PRODUCT CHANGE NOTICE

Date Submitted: 10 February 2017
 Model No.: DS3000TE-3, DS3000TE-3-001
 Product Description:
 Customer P/N: DS3000TE-3, DS3000TE-3-001
 Manufacturing Location(s) Affected: Laguna

Reason(s) for Change: Update Primary FW to address Crest Factor and Line Sag requirements. Update Secondary FW to address some PMBUS related deviation from PMBUS specs. Change R761 to 0R to improve Current Sharing Accuracy

1. Schematic Diagram (R761)

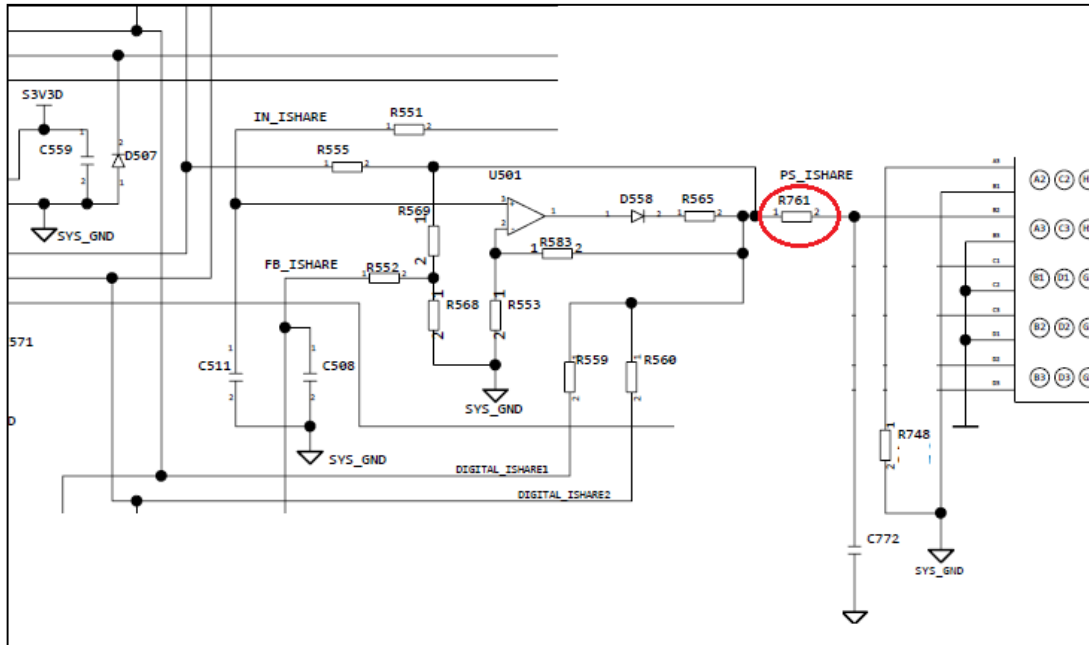
- (1) Update Primary Firmware to turn ON and OFF within the specified range when input is clipped with Crest Factor from 1.1 to 1.4.
- (2) Update Primary Firmware to allow the PSU to operate without loss of power during a line sag from 220Vac (or higher) down to 150Vac for 500ms and then back to 220Vac (or higher).
- (3) Update Secondary Firmware to address below deviations from PMBUS specs.
 - a. OPERATION command to clear Fan Fault.
 - b. Fault should be cleared if AC is removed for at least 1sec.
 - c. Invalid data for Fan Command shall report CML error.
 - d. Faults are not reported intermittently.
- (4) Change R761 to 0R to improve Current Sharing Accuracy.

Circuit Code		P/N	Description
R761	From	301-011706-1000	RES,DIS,TKF,100Ω,0.063W,1%,100ppm [TC],0402
	To	301-011706-0000	RES,DIS,TKF,0Ω,0.063W,1%,100ppm [TC],0402
SFTW1	From	630-003236-0001	SW,PRI,INTDEV, AC,DS3000TE-3-401-SP
	To	630-003236-0002	SW,PRI,INTDEV, AC,DS3000TE-3-401-SP
SFTW2	From	630-003726-0000	SW,SEC,INTDEV,DS3000TE-3 SERIES,DS3000TE-3
	To	630-003726-0001	SW,SEC,INTDEV,DS3000TE-3 SERIES,DS3000TE-3

Circuit Code		P/N	Description
R761	From	301-011706-1000	RES,DIS,TKF,100Ω,0.063W,1%,100ppm [TC],0402
	To	301-011706-0000	RES,DIS,TKF,0Ω,0.063W,1%,100ppm [TC],0402
SFTW1	From	630-003236-0001	SW,PRI,INTDEV, AC,DS3000TE-3-401-SP
	To	630-003236-0002	SW,PRI,INTDEV, AC,DS3000TE-3-401-SP
SFTW2	From	630-003727-0000	SW,SEC,INTDEV,DS3000TE-3 SERIES,DS3000TE-3-001
	To	630-003727-0001	SW,SEC,INTDEV,DS3000TE-3 SERIES,DS3000TE-3-001
